S4.55 CHANGES

CLIENT: ANGLICARE CASTLE HILL
ADDRESS: 284 CASTLE HILL RD, CASTLE HILL NSW 2154
DRAWING: EXISTING & DEMOLITION PLAN WEST

PROJECT
201656 WESTERN ROAD

APPROVED BY: CA
CHECKED BY: TW
CLIENT: ANGLICARE CASTLE HILL
ADDRESS: 284 CASTLE HILL RD, CASTLE HILL NSW 2154
DRAWING: ELEVATIONS - BUILDING 9B

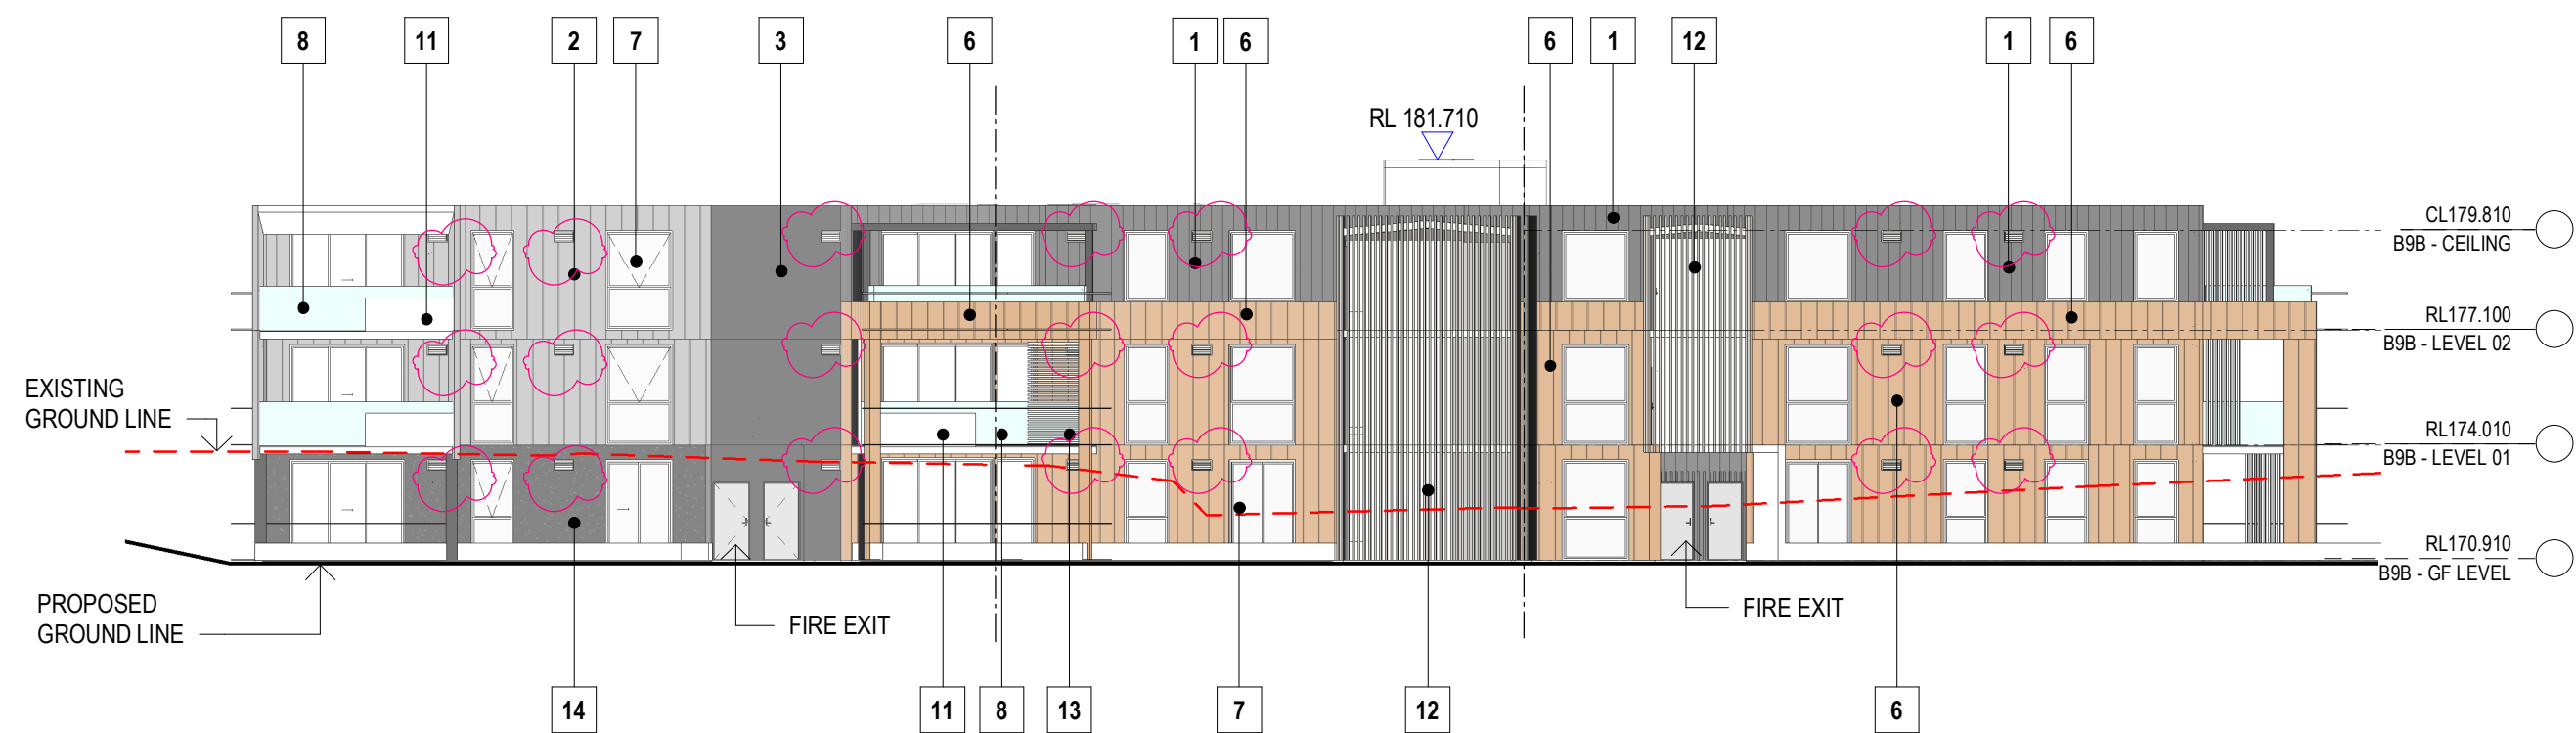
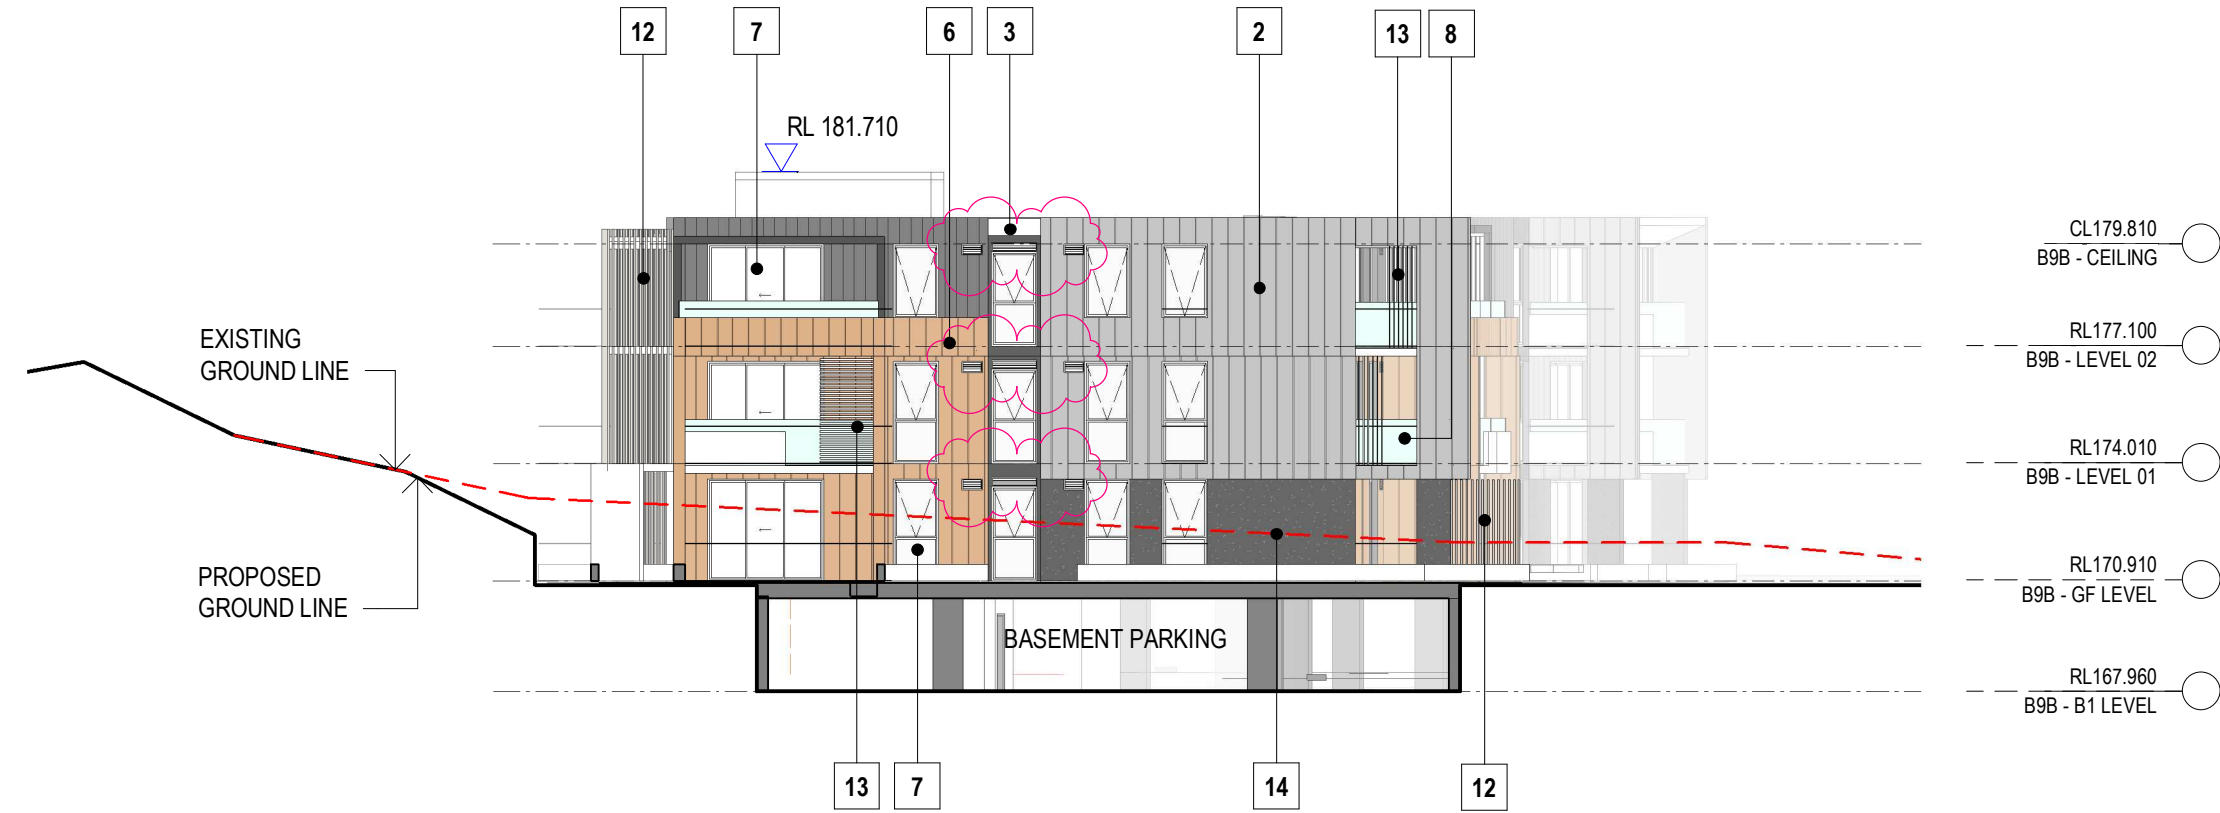
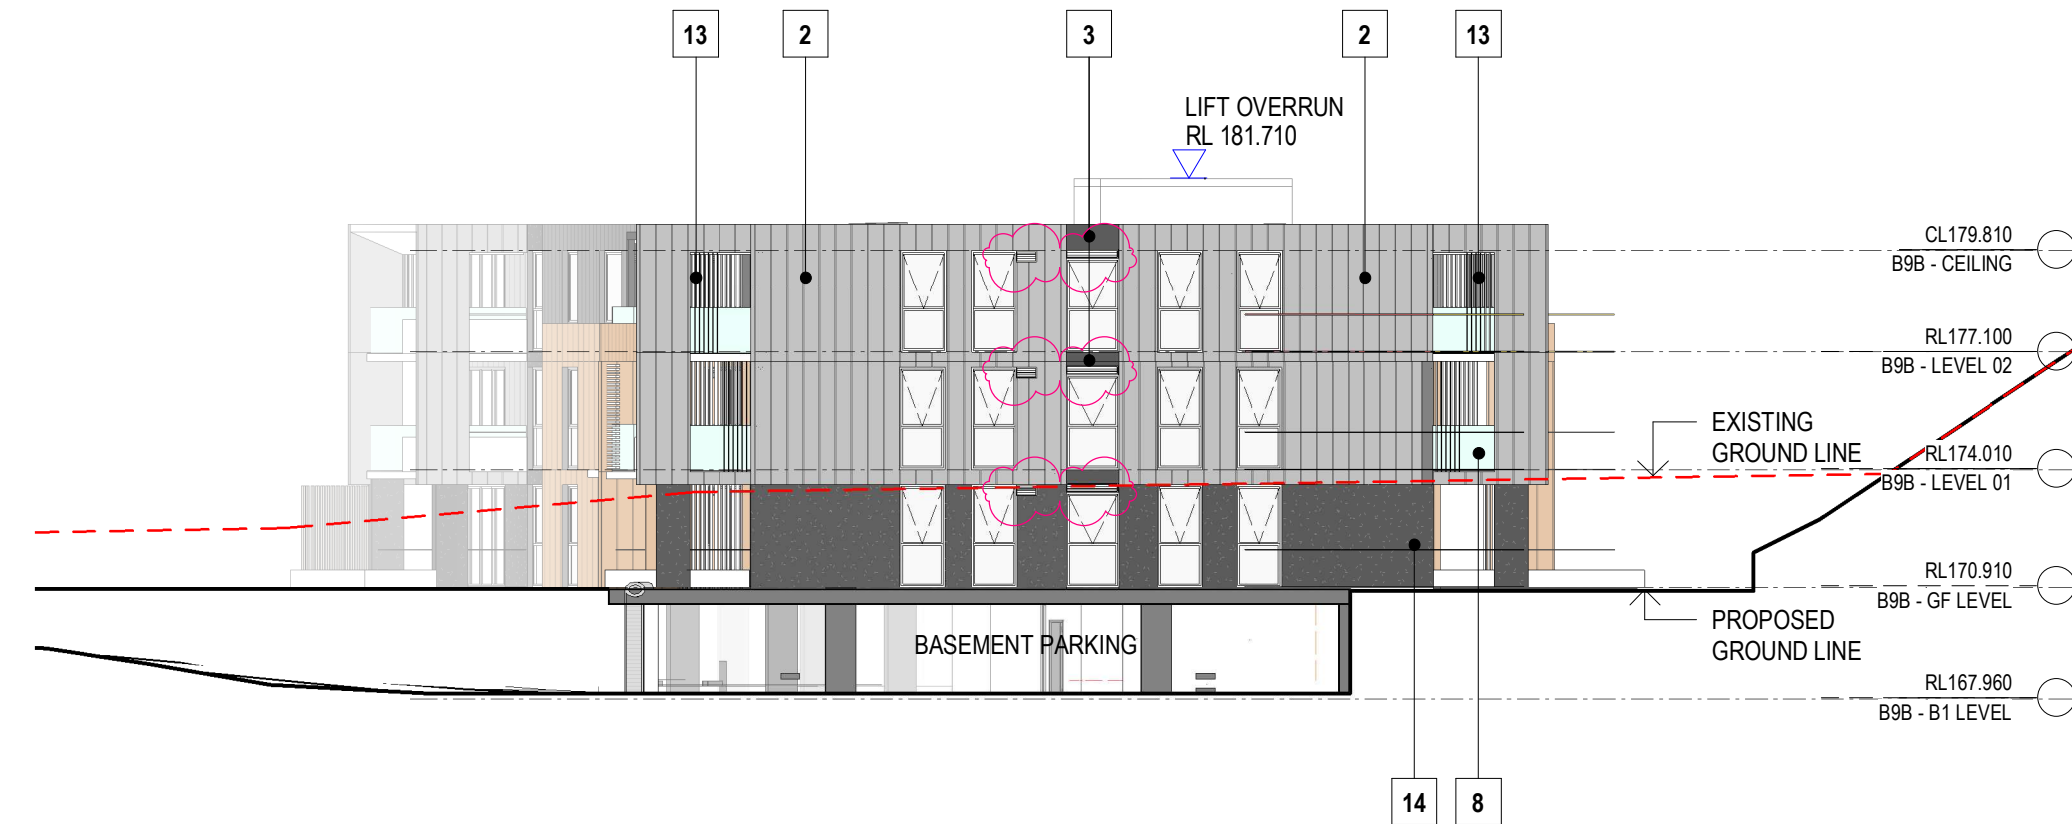
- MECHANICAL LOUVRES ADDED
